Mercedes-Benz

Campaign No. 2019080012, August 2019

SUBJECT: **Model C-class (205 platform), E-Class (213 platform), E-Class Coupe (238 platform), and CLS-Class (257 platform)**
Model Years 2018-2019
Replace Steering Rack

Figure 1

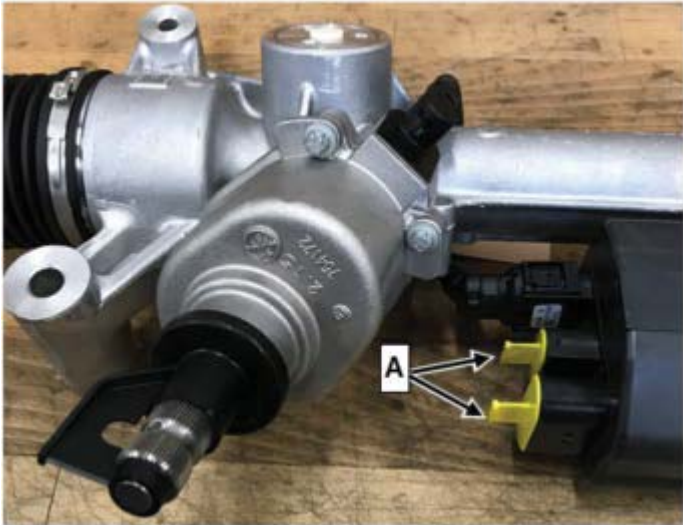
i To prevent dirt from entering the connector couplings or damage from ESD (electrostatic discharge), it is **absolutely essential** to fit the yellow dust caps (**A, Figure 1**) on the connector couplings of the steering gear to be returned. The **caps** from the **new** steering gear are to be used for this.

i If these dust caps are **not** fitted, it will **not** be possible to carry out an analysis.
This could affect the warranty process.
